**PLANNING BOARD  
REGULAR MEETING  
TUESDAY FEBRUARY 23, 2016  
7:00 PM  
HOOD ROOM, MATTHEWS TOWN HALL**

## Agenda Item: Administrative Amendment

**DATE:** February 16, 2016  
**RE:** Fullwood Station  
**FROM:** Mary Jo Gollnitz, Planner

The developer of Fullwood Station, Provident Land Services, is requesting an Administrative Amendment to their approved Rezoning Application 2014-621. The request includes *i)* removal of the proposed pedestrian access connection between lots #4 and 5; *ii)* change conditional note to allow removal of all the existing trees along South Trade Street; *iii)* change conditional note to allow for 5' berm along South Trade St; *iv)* to change notes in order to terminate mulch walking trail internal to the subdivision with a turnaround; and *v)* approve new home elevations.

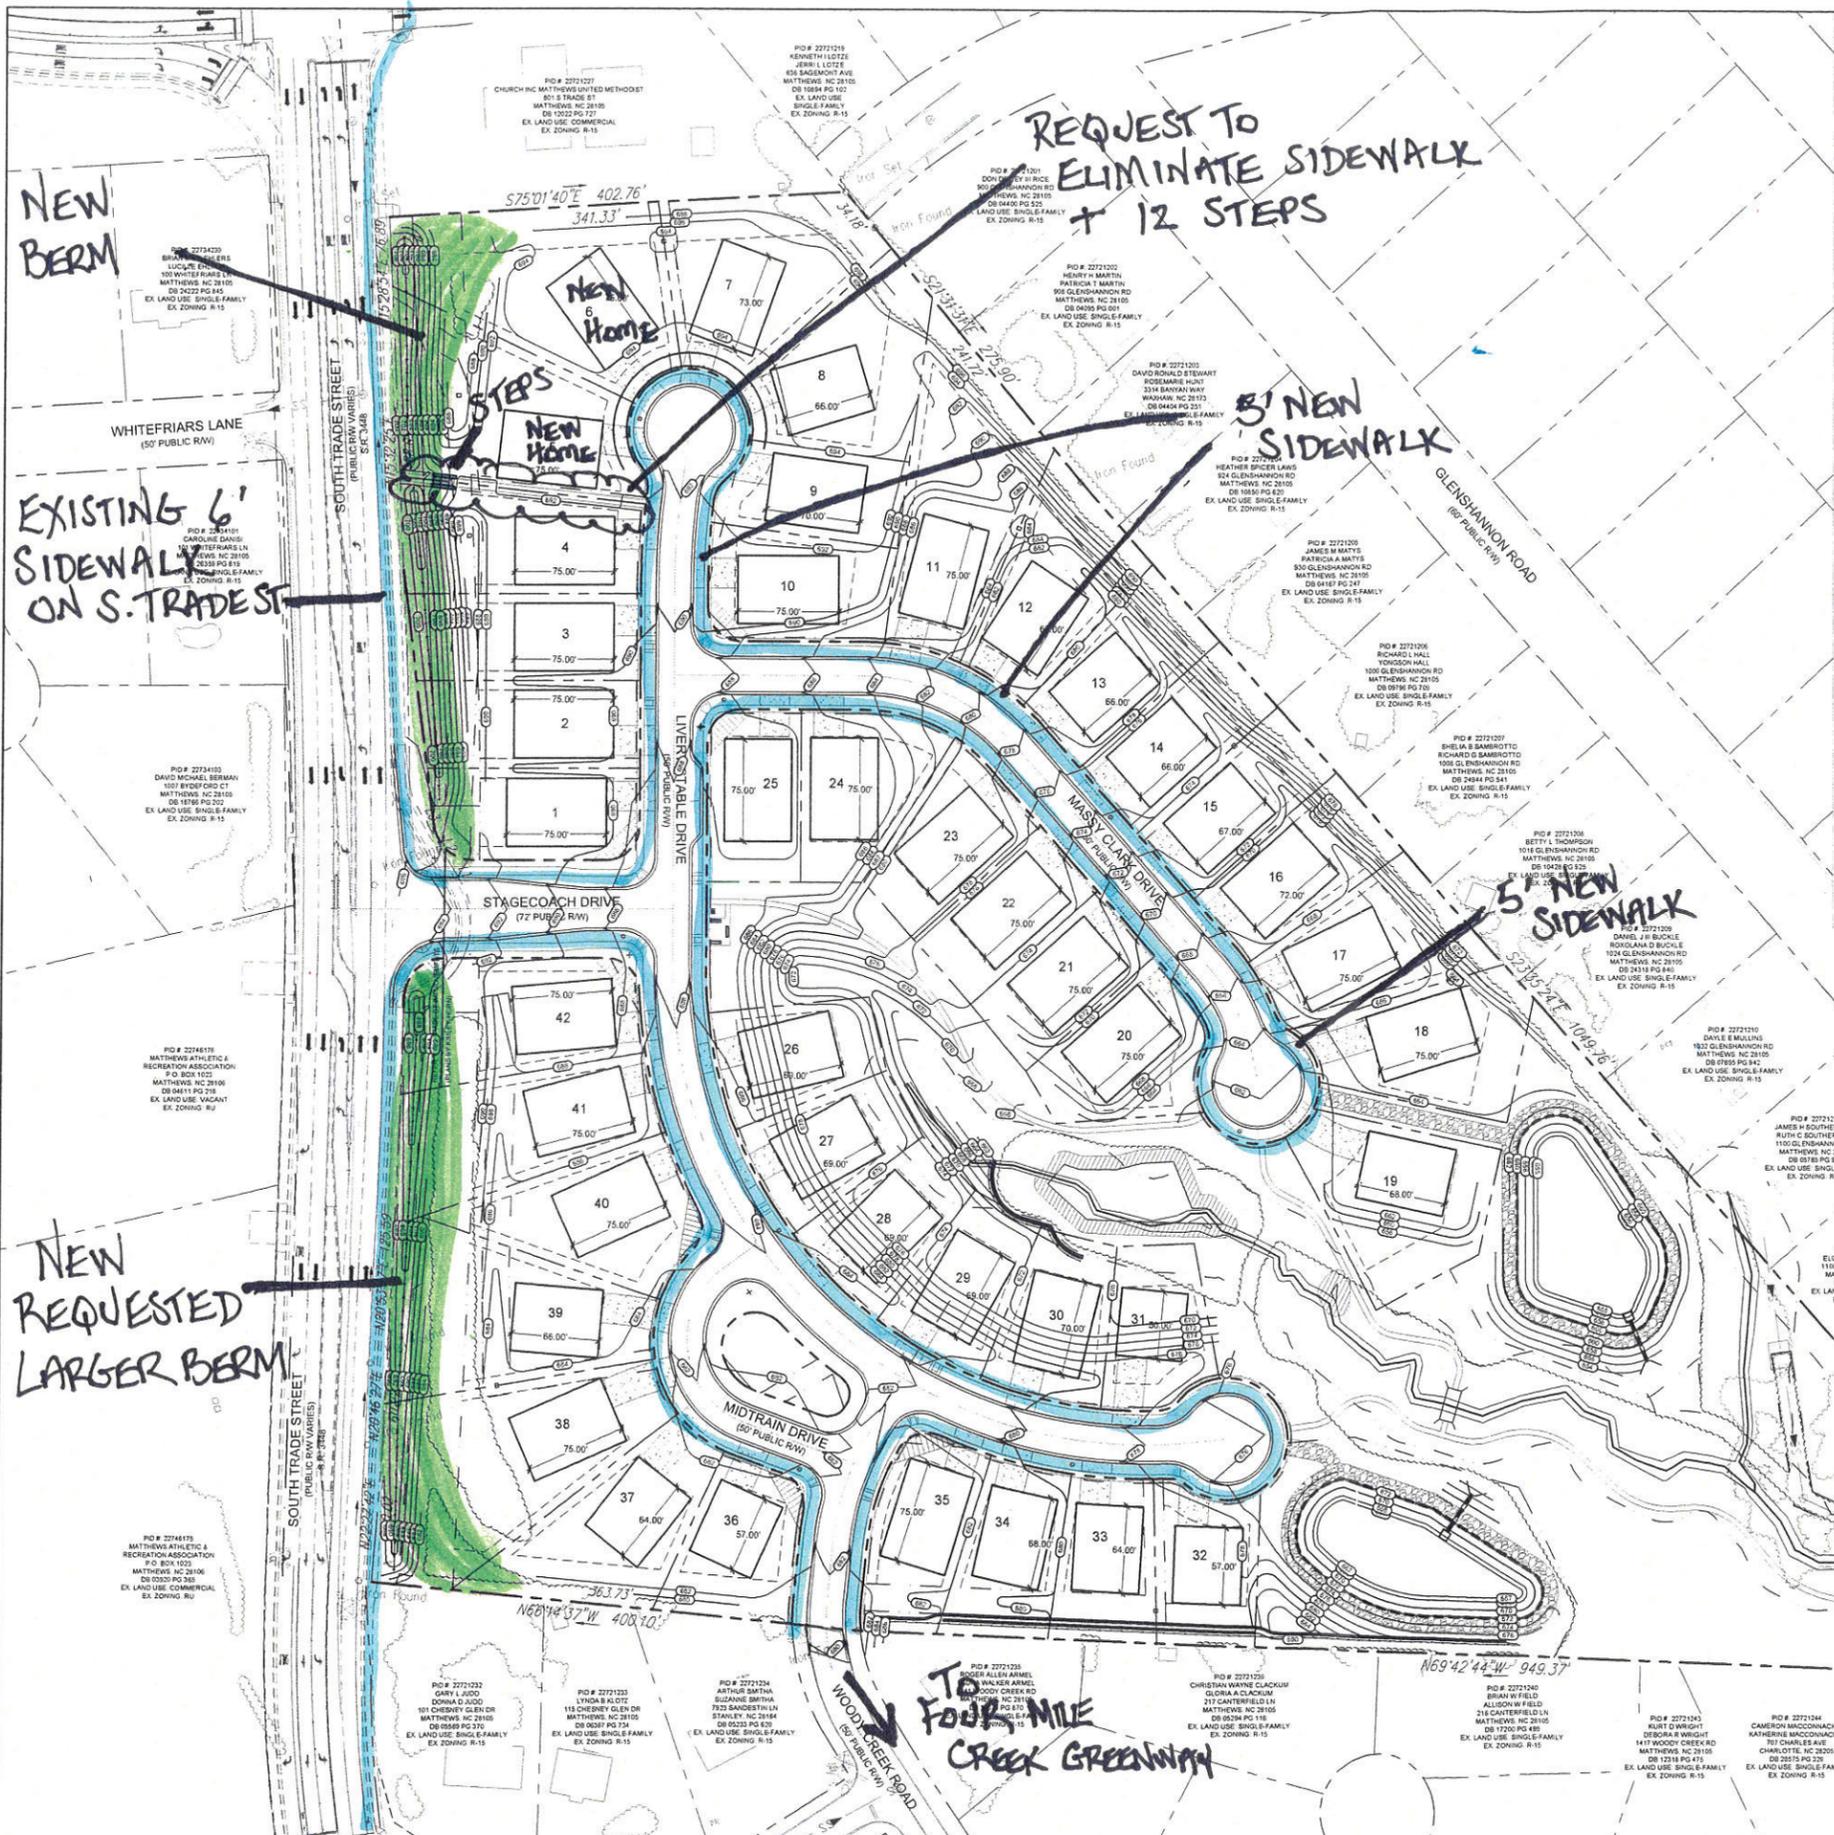
As requested in our rezoning document for Fullwood Station, we met with Bob and Rita Ehlers on Saturday, January 30, 2016 to discuss their pool and fence encroachment, and also requested access for our pedestrian trail connection next to their home leading out to Woody Creek Drive.

During our visit, Mr. Ehlers confirmed that he had done some research and agreed that a small portion of his concrete pool deck and wooden fence, do indeed, encroach onto our property; however, The Ehlers consulted with many of their neighbors in Chesney Glen and have decided that they do not want this trail connection alongside their property. They are very concerned about security and privacy, and believe that a public trail so close to their back porch and pool would have a significant negative impact. They would like to buy a small portion of land from us to extend their property to include the encroaching areas. We told them we would consider this request.

Due to the Ehlers strong concern over the pedestrian trail, we will terminate our mulch trails within our own Common Open Space/Greenway, as referenced in our rezone petition.
